Board of Architectural Review

DATE: November 20, 2019
TO: Board of Architectural Review Chair and Members
THROUGH: Jason Sutphin, Community Development Division Chief (JDS)
FROM: Tommy Scibilia, BAR Liaison (TS)
SUBJECT: **9571 Fairfax Boulevard**

1. Case Number:	BAR-19-00789
2. Addresses:	9571 Fairfax Boulevard
3. Request:	New commercial building and site improvements
4. Applicant:	9571 Fairfax Boulevard, LLC
5. Applicant's Representative:	Stuart Schooler
6. Status of Representative:	Property owner
7. Zoning:	CG Commercial General, Architectural Control Overlay District

NORTHWEST ELEVATION

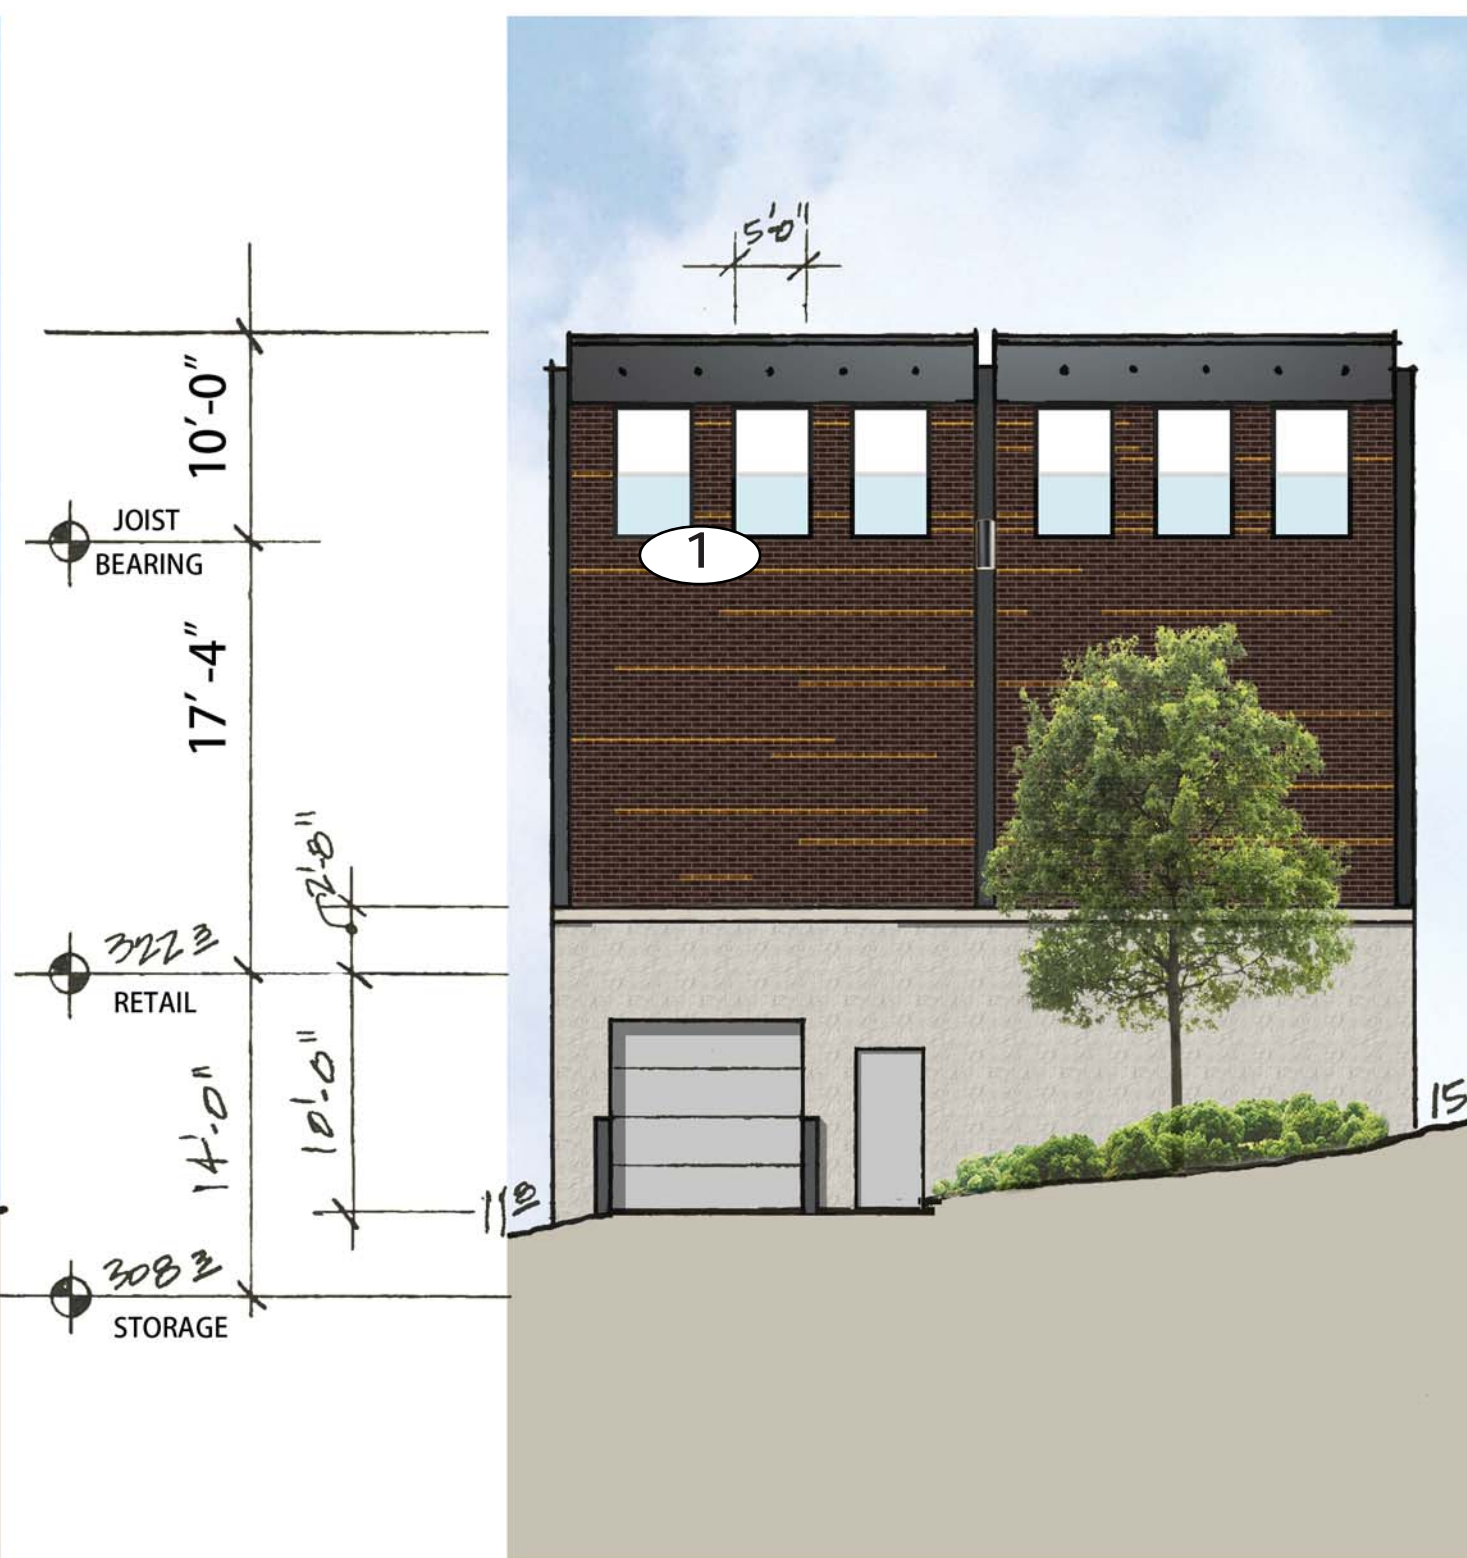
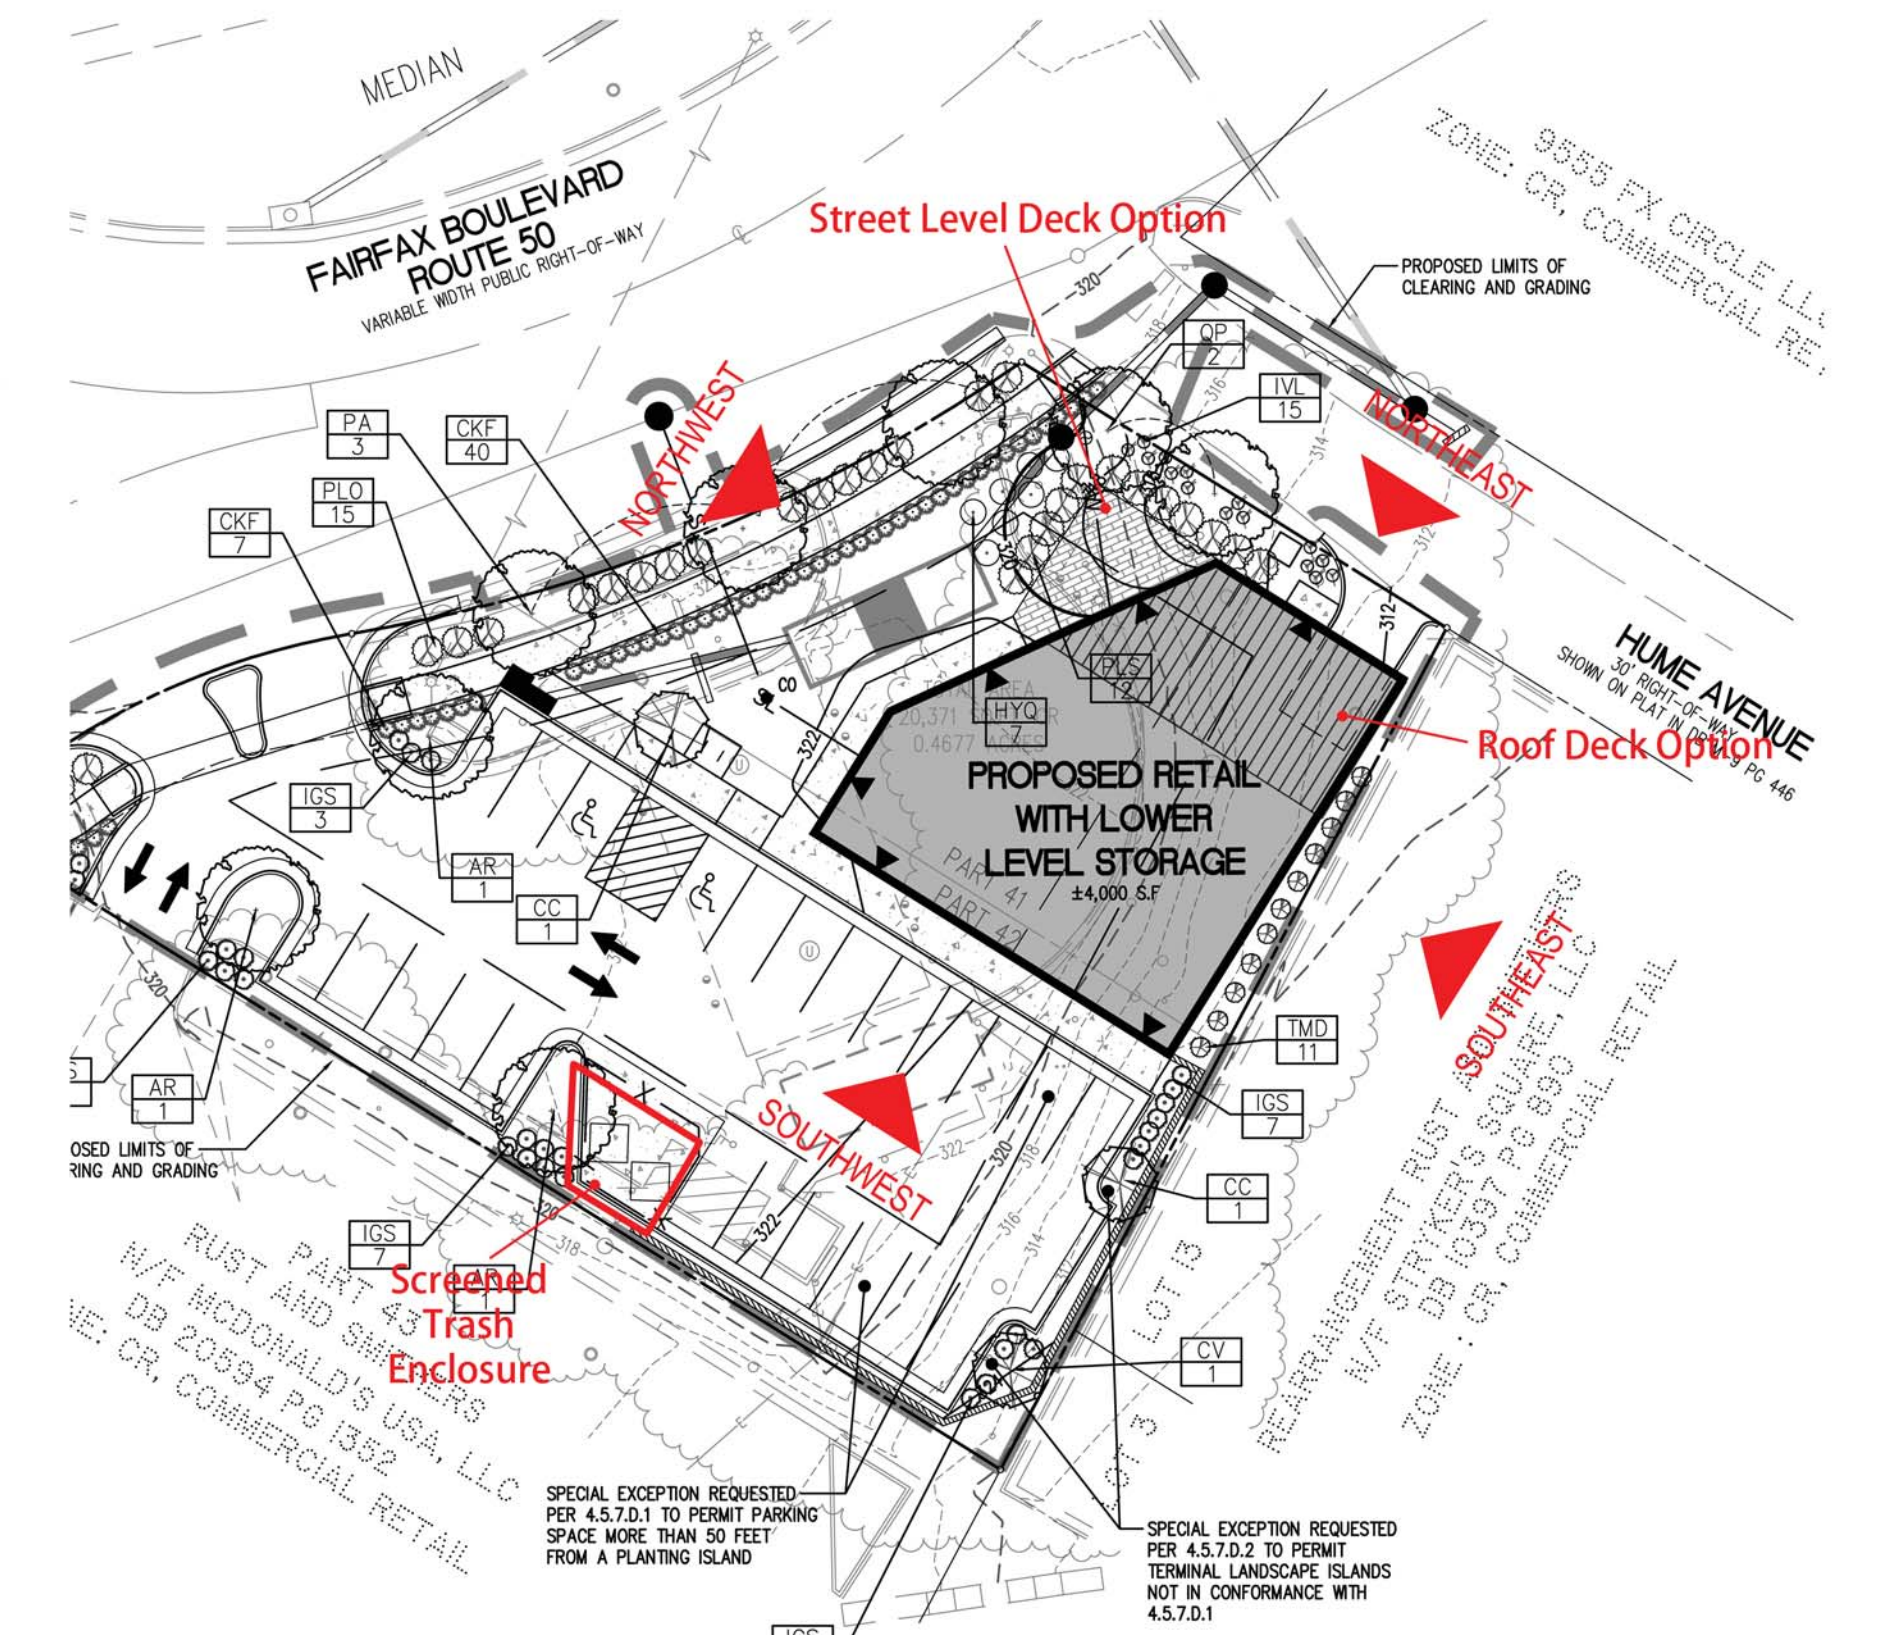
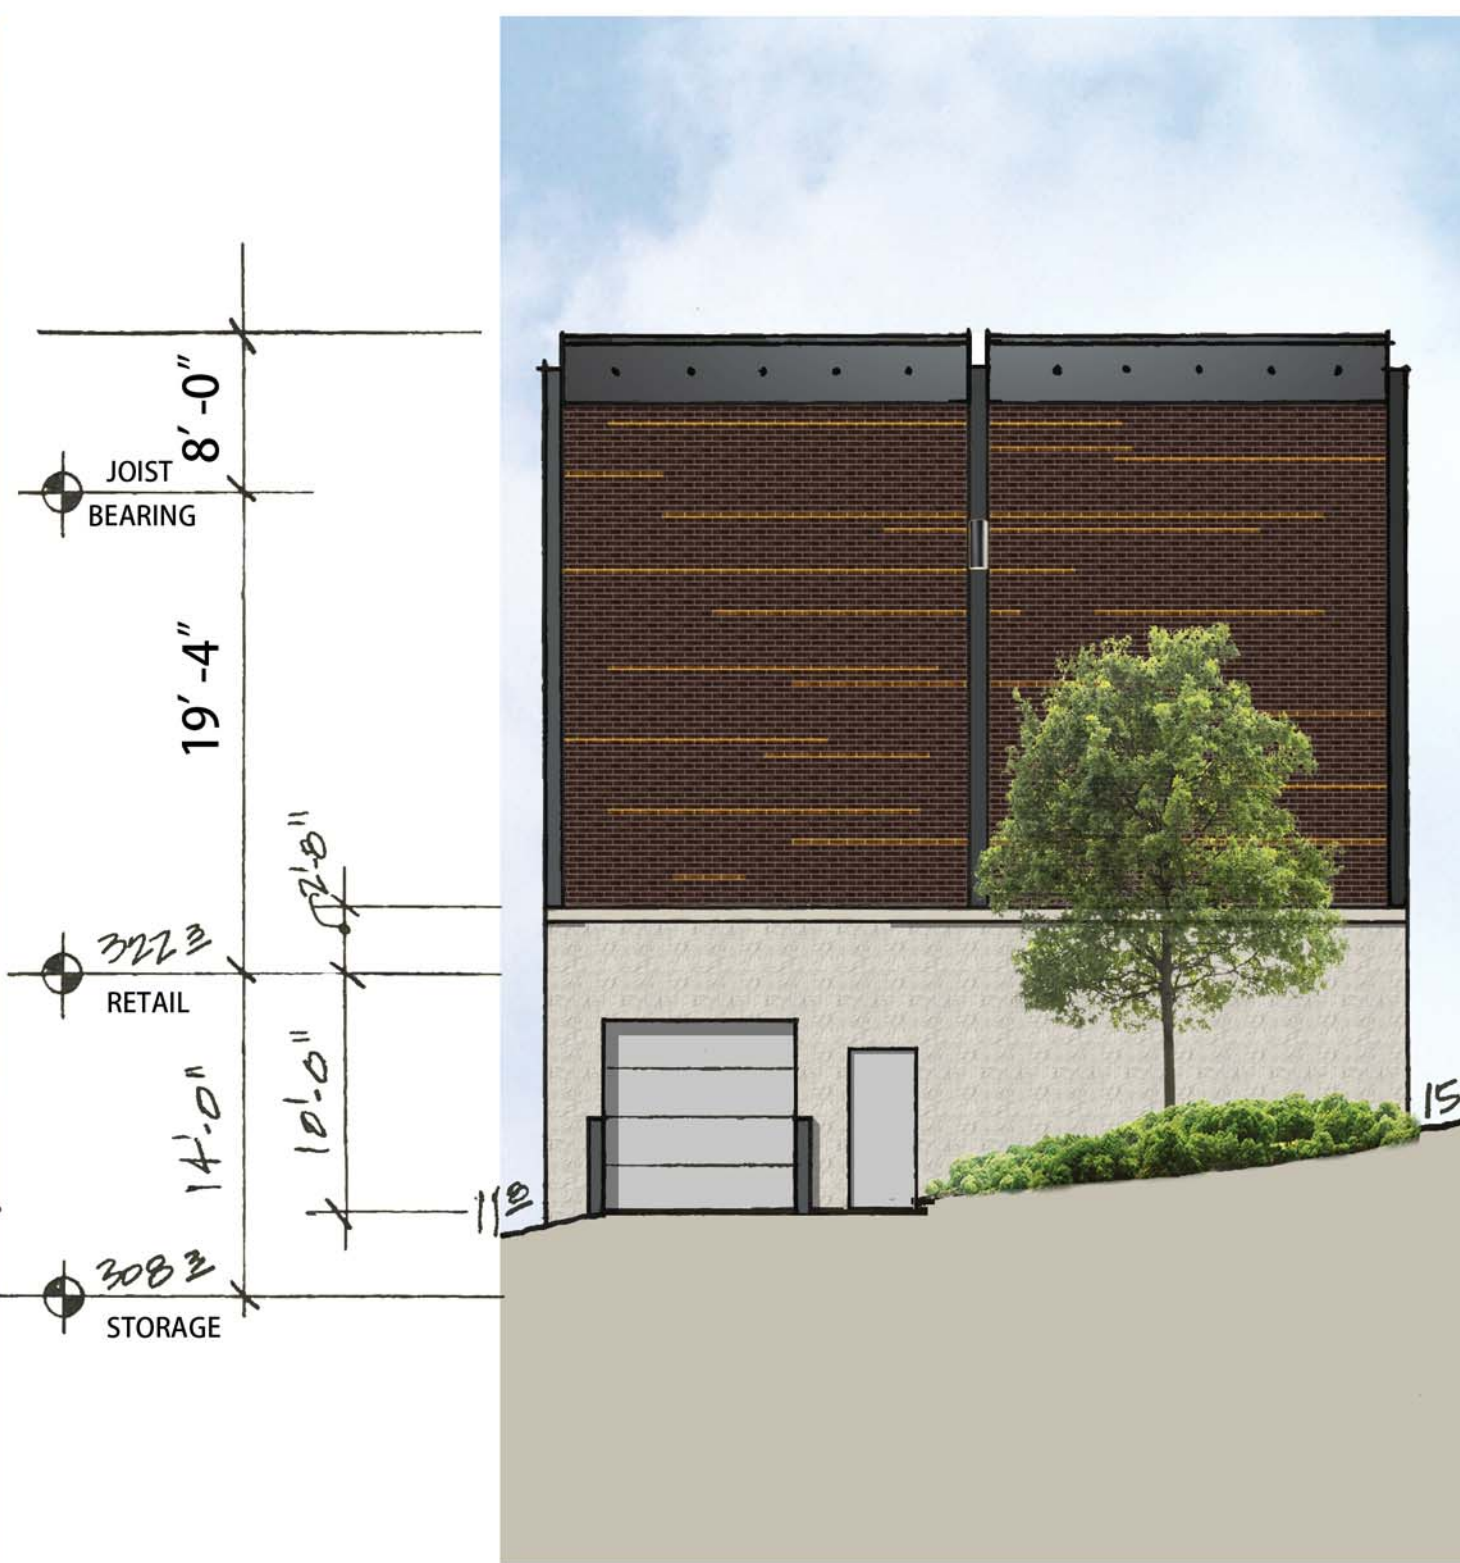
Staff believes that the use of reveals to create bays, the varied roofline, and the wall recesses would all help articulate the form of the building.

Staff finds the elevated roofline of the western corner to give this portion of the building visual prominence. The flat roof form is a contemporary design treatment consistent with neighboring building forms.

Staff believes that the entrances and storefront would be well-integrated and located in highly-visible locations on the building. The openings on the northeastern façade proposed for the Option 1 rooftop seating reflect the verticality of the other openings in the building design, and create additional transparency. Spandrel glass is not proposed.
